Before the
United States Nuclear Regulatory Commission
Docket Nos. STN 50-498, STN 50-499
Houston Lighting & Power Company, et al.
South Texas Project Units 1 & 2
Amendment 6

Amendment 6 provides information regarding the High Voltage Direct Current (HVDC) facility to be located on the STP site.

Instructions for incorporating Amendment 6:

SITE LAYOUT AND SURROUNDING
AREAS OF SOUTH TEXAS PROJECT
FIGURE 2.1-4

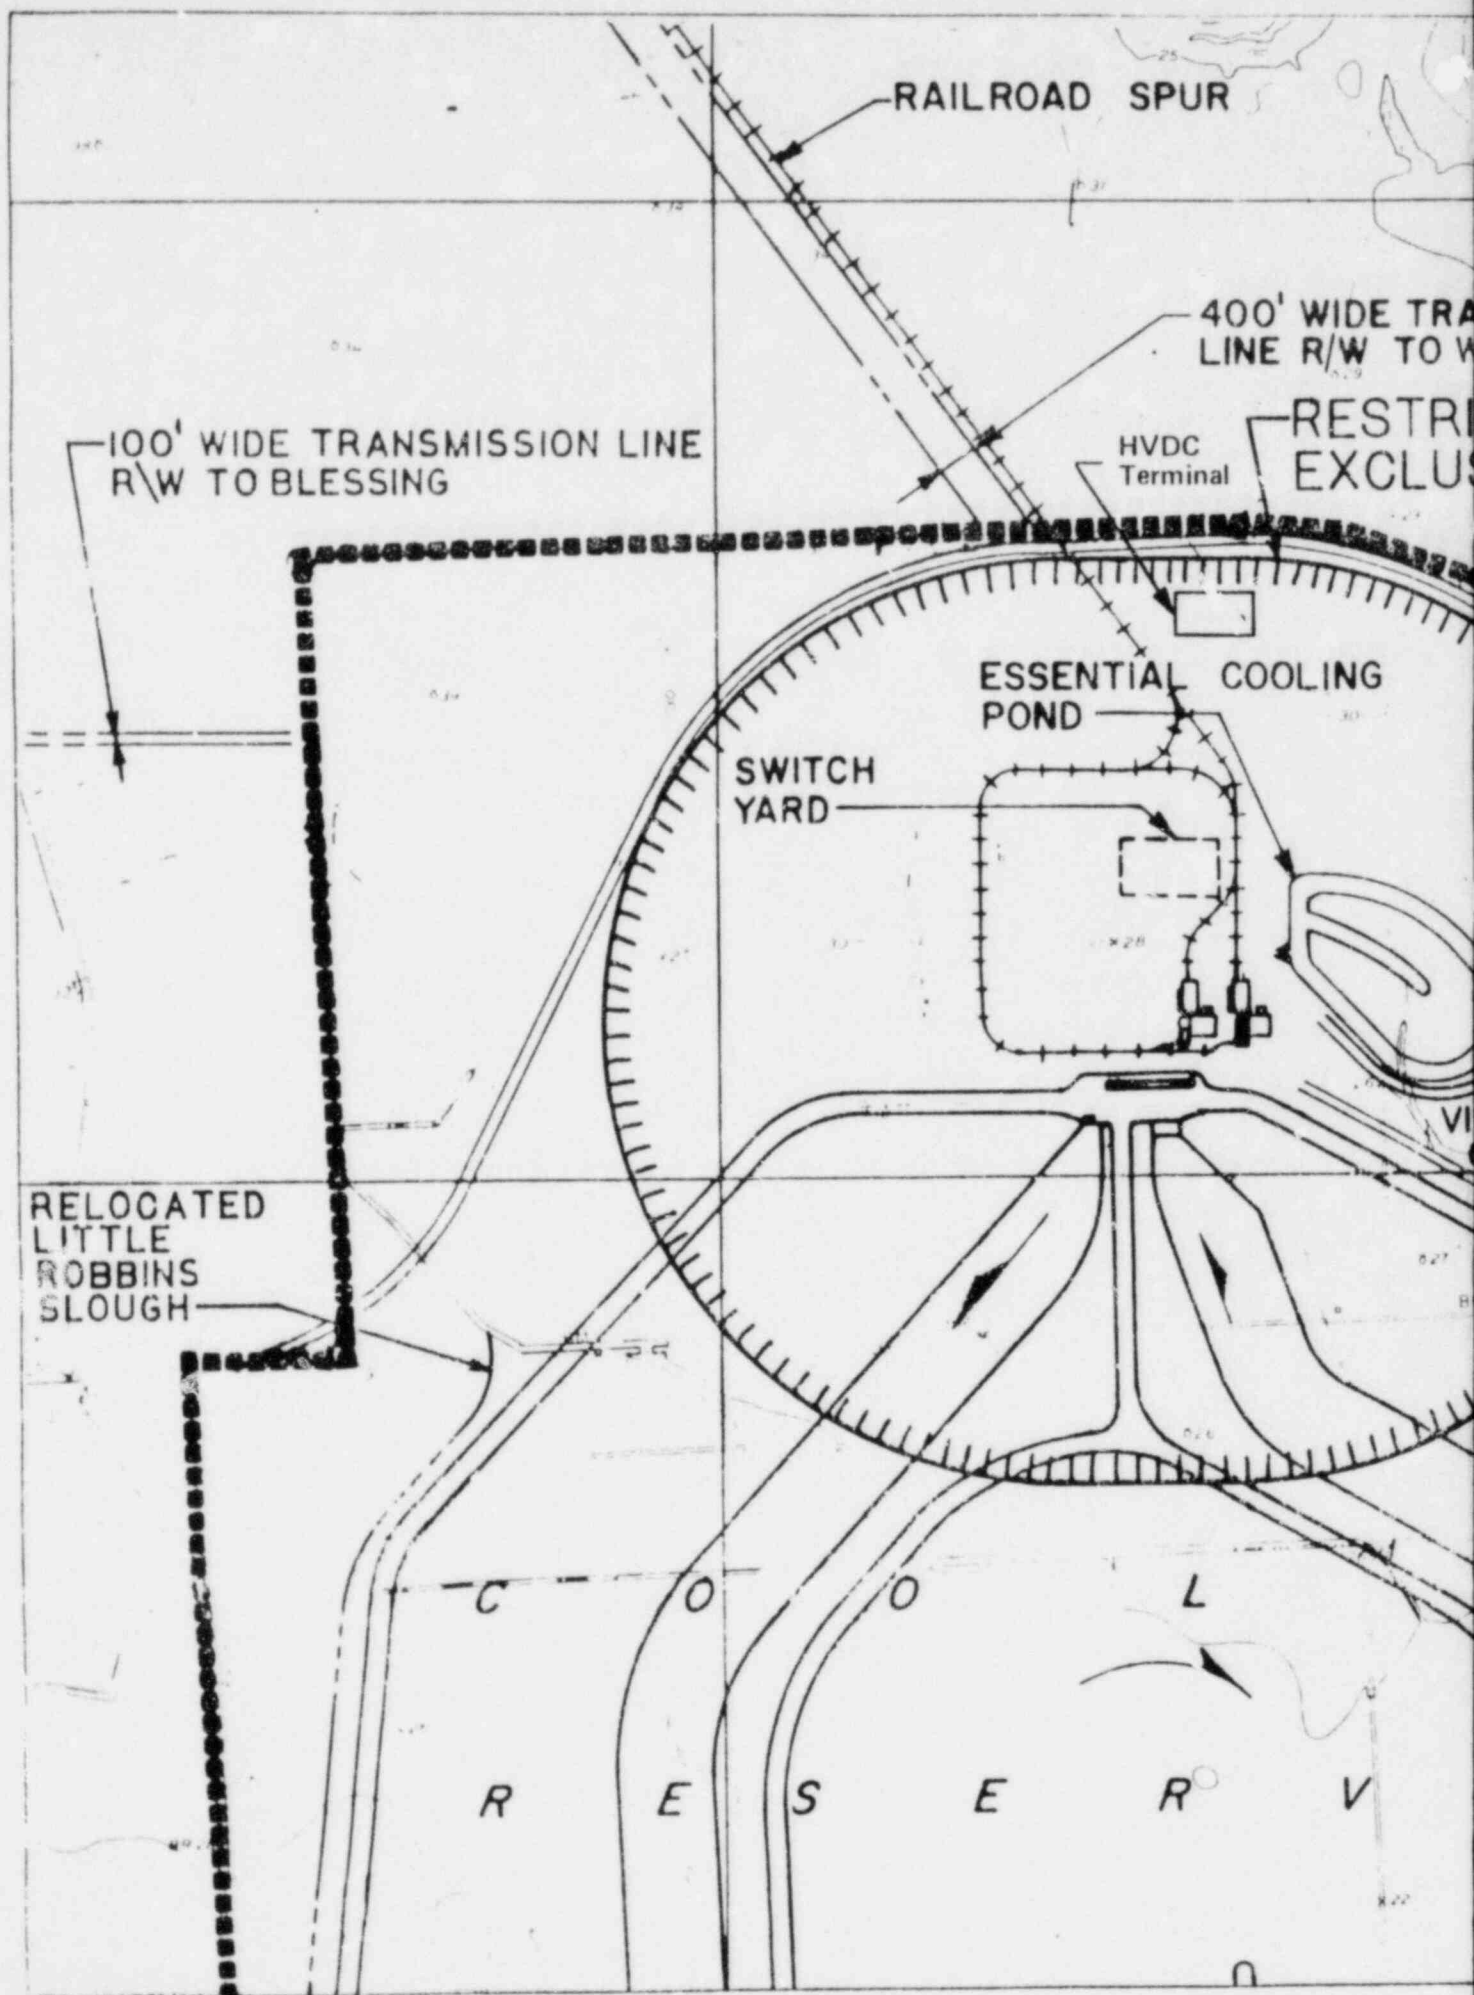
A High Voltage Direct Current (HVDC) terminal will be operated by Central Power and Light Company on a 17 acre tract in the exclusion area which will be leased to the HVDC project by the STP. The HVDC terminal is shown in Figure 2.1-4.

A High Voltage Direct Current (HVDC) interconnection (-400 kV) is to be operated between terminals at the Central and South West System Walker County Power Plant and the STP. The southern terminal is to be located on a 17-acre tract of the STP site southeast of the intersection of the FM 521 and the STP construction access road, just inside and adjacent to the Exclusion Area Boundary as shown on Figure 2.1-4. The terminal will consist of an AC switchyard, and AC-DC converter building, and a DC switchyard. A 345 kV line consisting of one circuit will connect the STP switchyard with the terminal.

SITE BOUNDARY
RESTRICTED AREA & EXCLUSION AREA
FIGURE 2.1-5

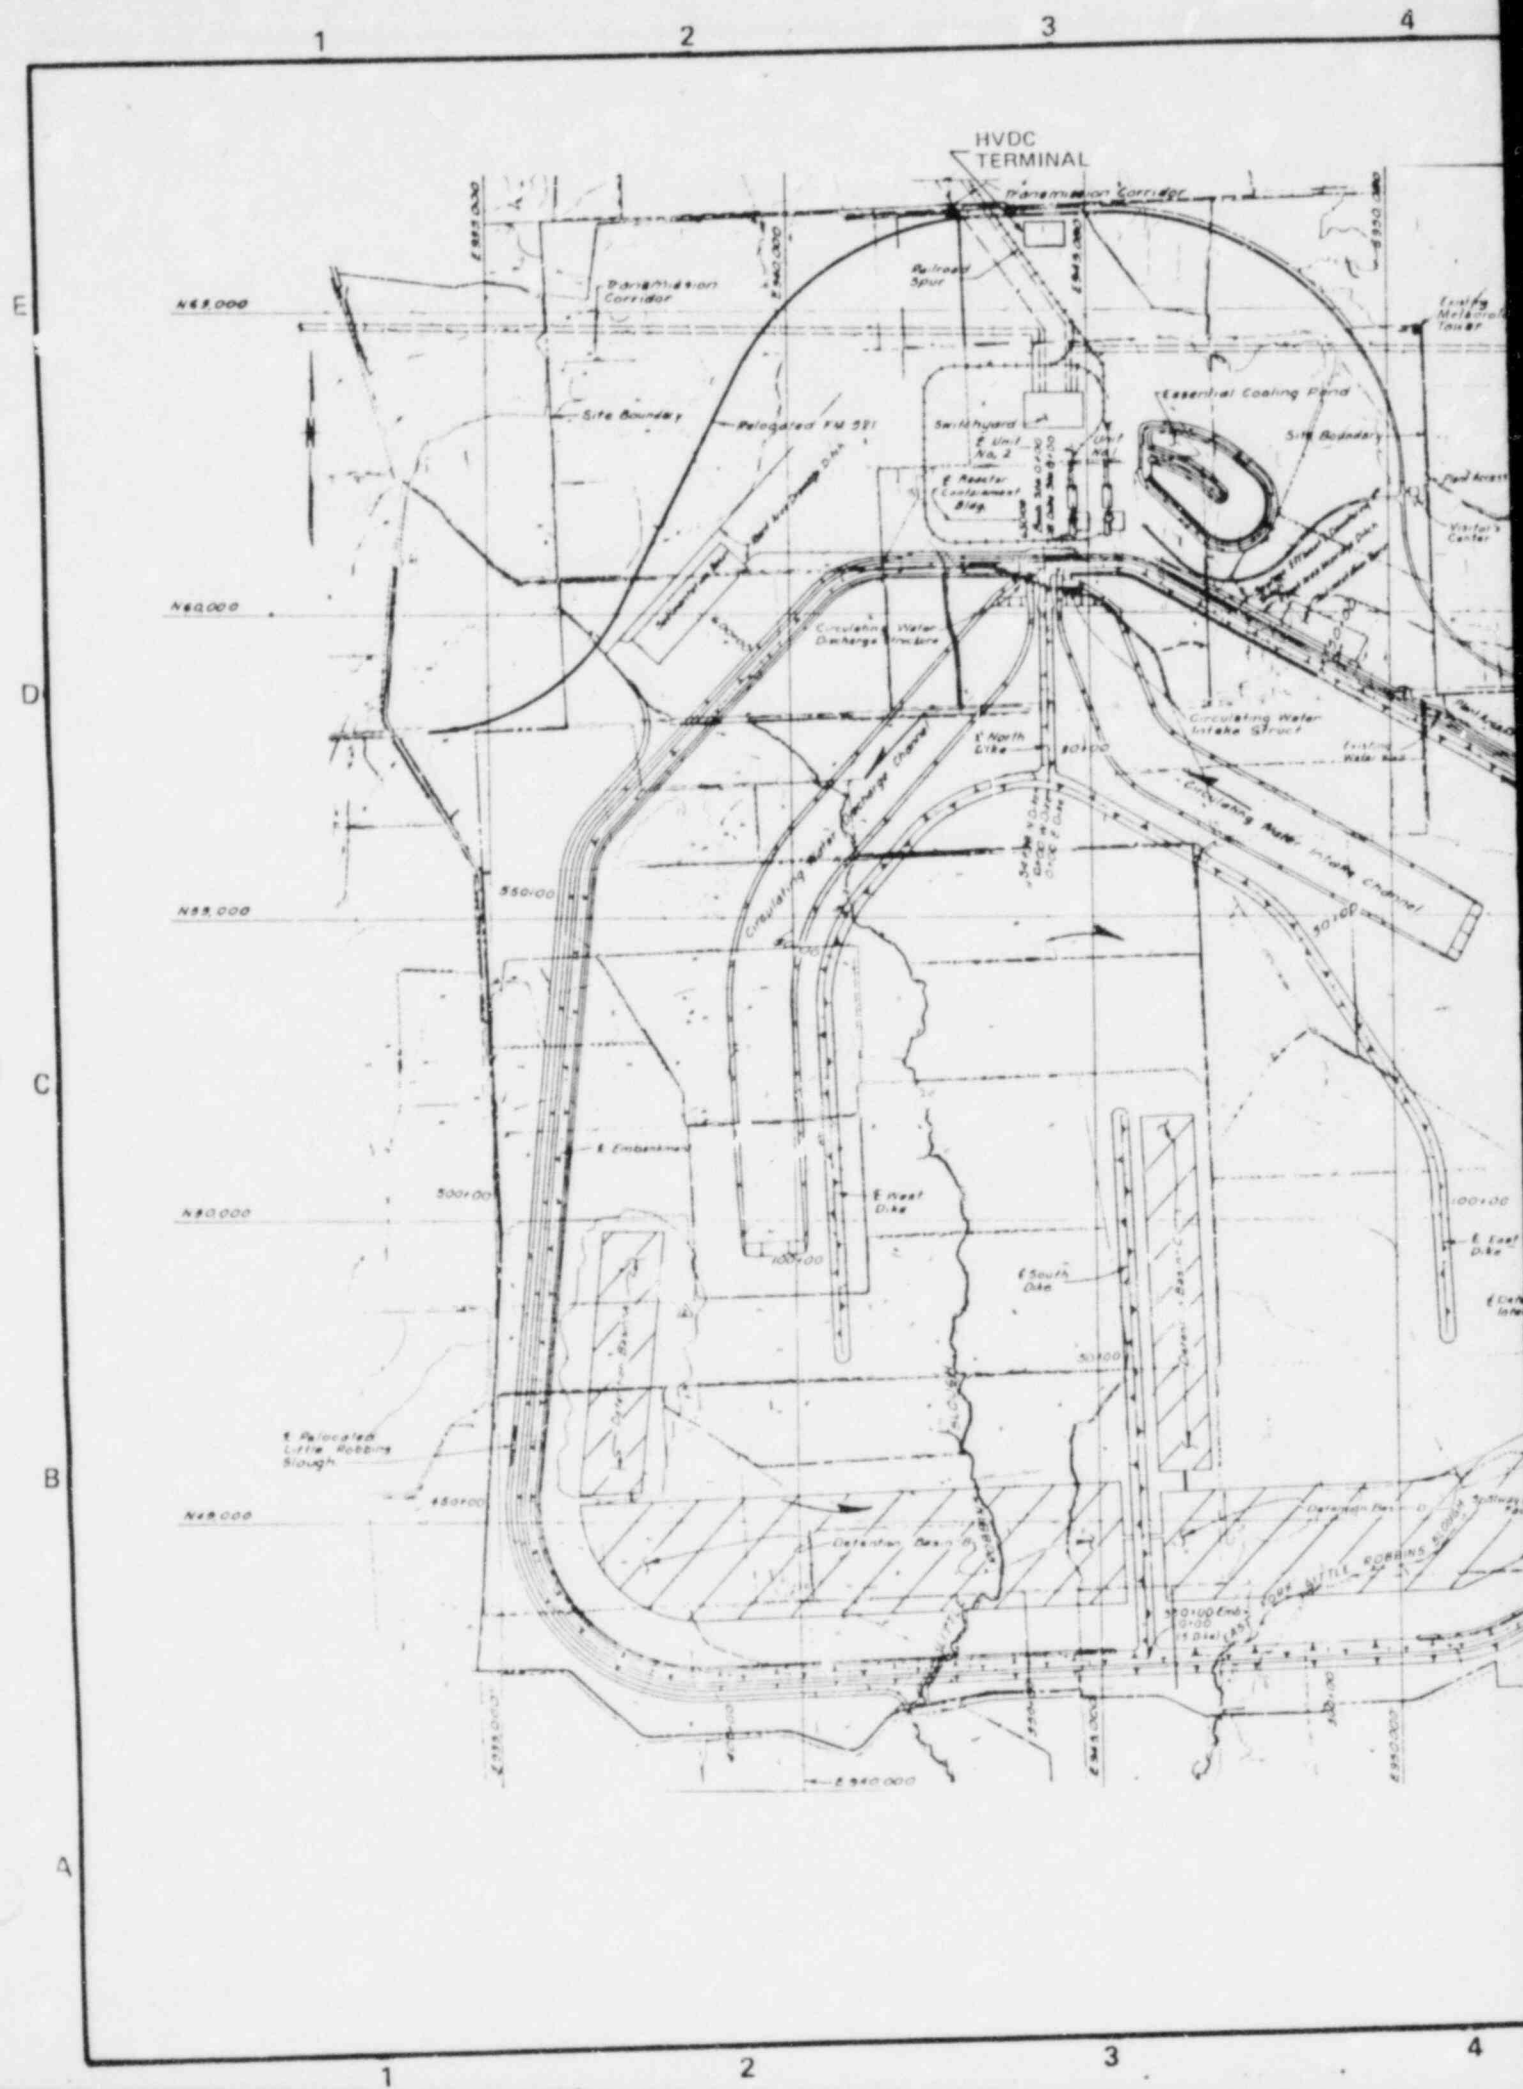
2.2.1.2.1 Visitors' Center. As previously discussed in Section 2.1, a visitor's information center will be constructed on the STP site. (Figure 2.1-5.) Attendance figures at the visitors' center are expected to approximate 30,000 annually.

FIGURE 2.1-7

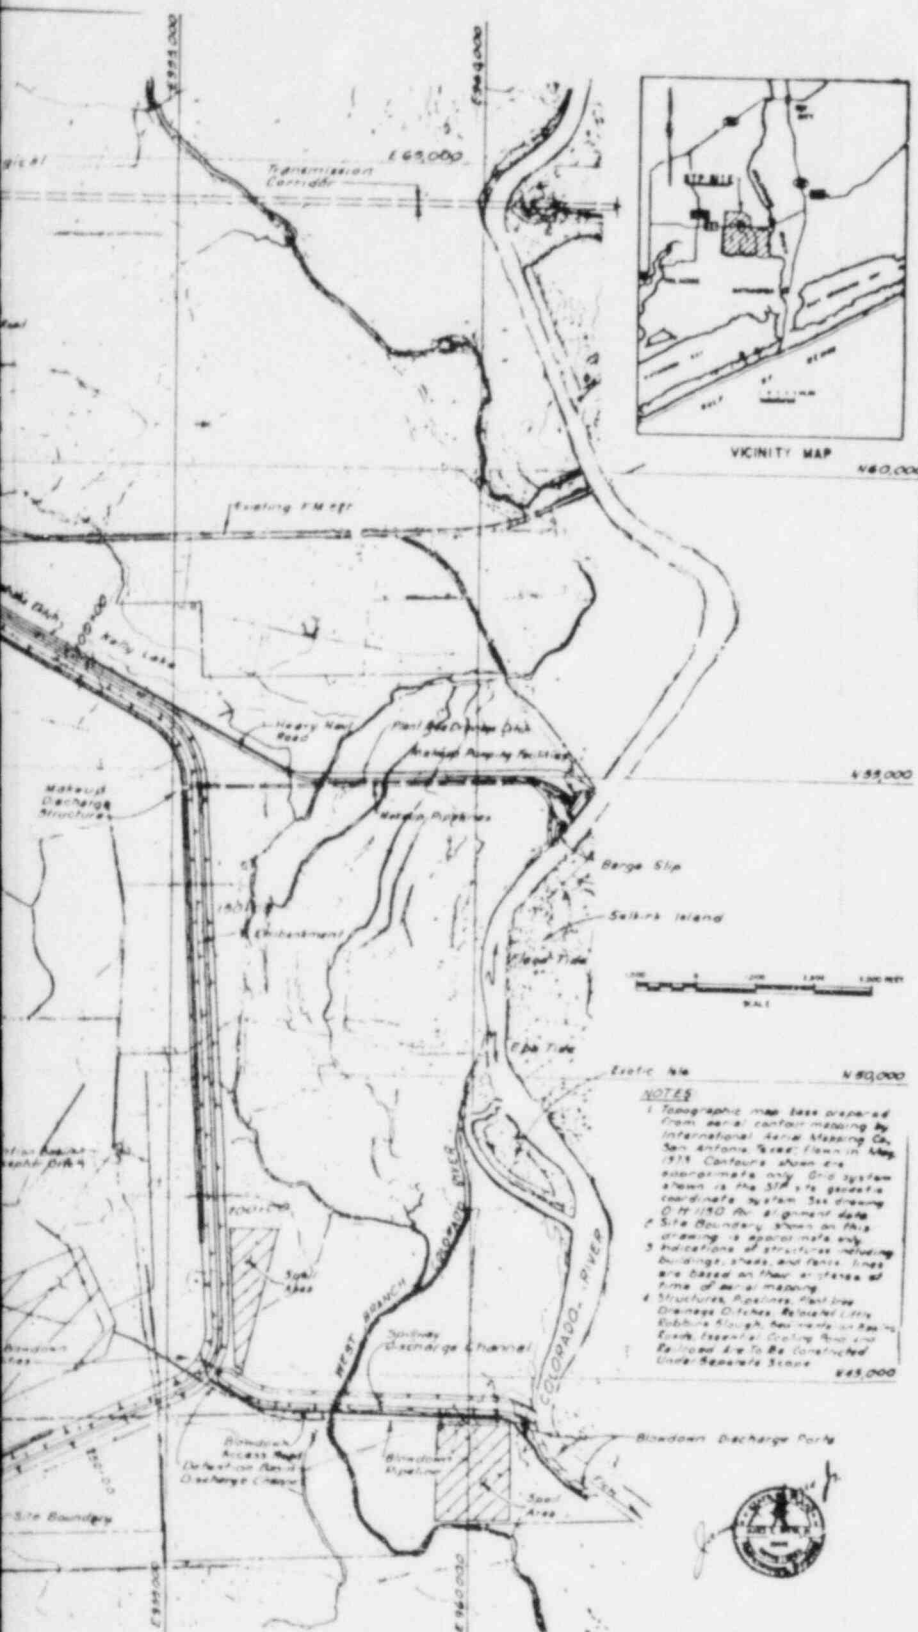
Major road access to the site will be from farm-to-market road (FM) 521. The site development plan, shown on Figure 2.1-7, reflects the major features of plant development. The main element of the plan is the nuclear power plant and its support facilities. The plant was sited to enable functional and safe operation of a nuclear power plant compatible with the natural environment of the surrounding site and community.
